# Technical Service Information

## FORD E40D NO FLOW TO COOLER, AFTER REBUILD

Figure 1

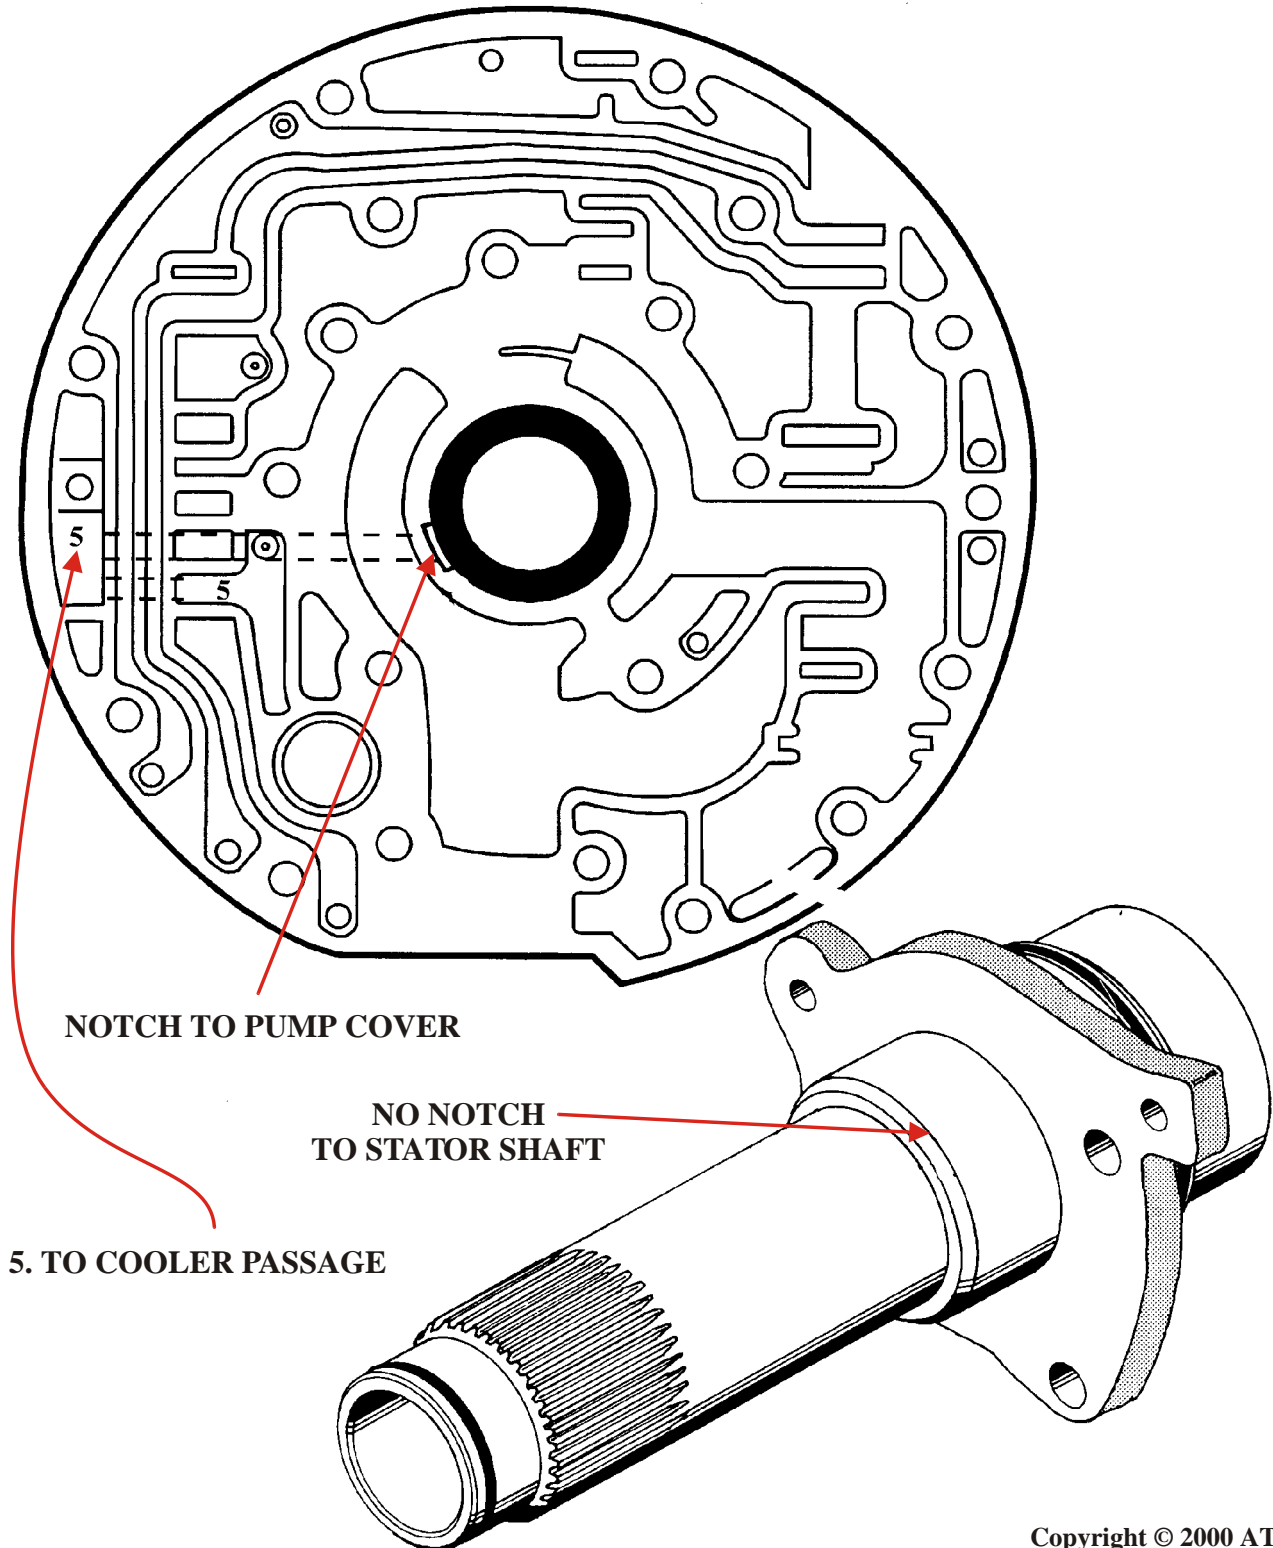
**(1) 89-94 MODELS** - Have a relief (Notch) cut into the pump cover on the inside diameter, where the stator shaft presses into the cover, creating a passage for converter apply oil to get into the “To Cooler” passage in the pump cover. Refer to Figure 1.

**89-94 Model** pump cover with notch, **MUST** be used with the stator shaft without notch. Refer to Figure 1.

Figure 2

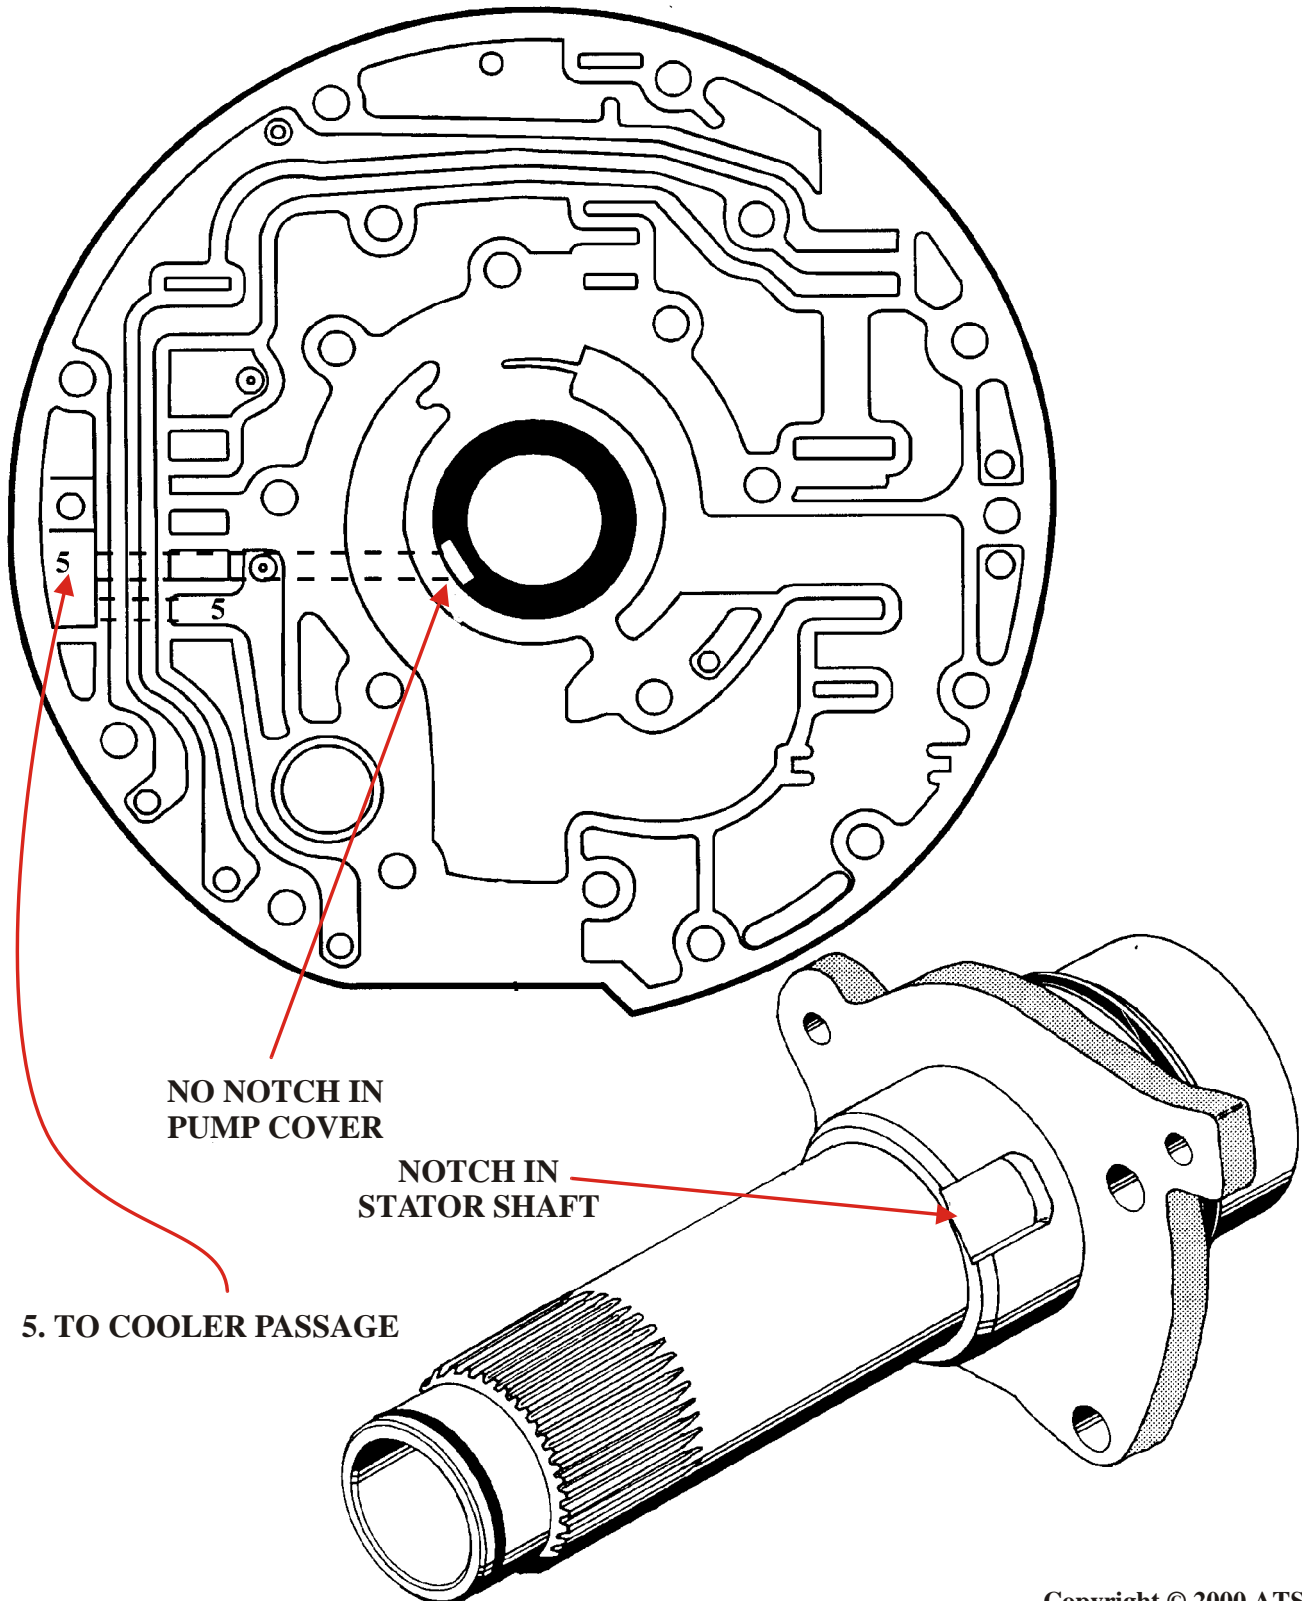
**(2) 95-96 MODELS** - The relief (Notch) cut in the pump cover was eliminated from the cover, and the relief (Notch) cut was added to the stator shaft (See Figure 2).

**95-96 Model** pump cover without notch, **MUST** be used with the stator shaft with notch. Refer to Figure 2. If you install a 89-94 stator shaft without notch, into a 95-96 pump cover without notch You will create a totally blocked “To Cooler” passage in the pump cover. Refer to Figure 3.

Figure 3

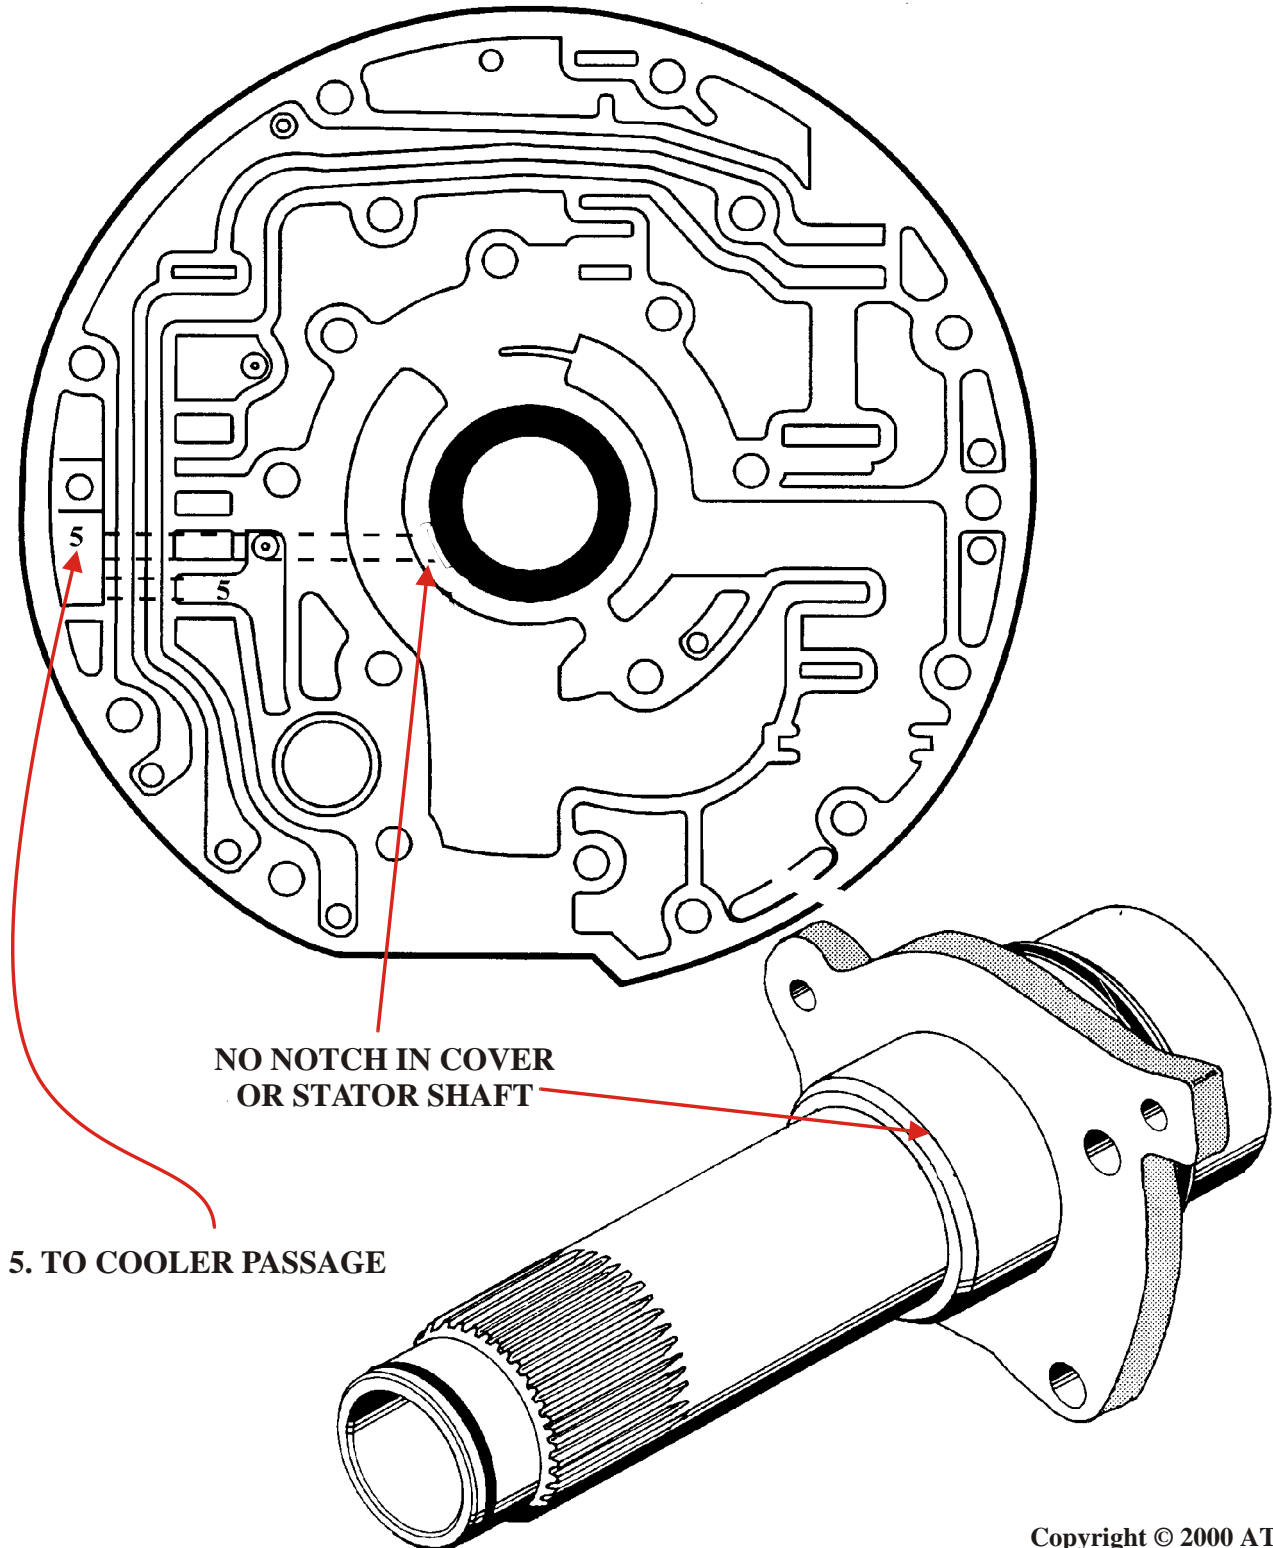
**1989 - 1994 PUMP STATOR (WITHOUT NOTCH) WITH  
1995 - 1996 PUMP COVER (WITHOUT NOTCH)  
WILL CAUSE TOTAL BLOCKAGE TO COOLER PASSAGE**
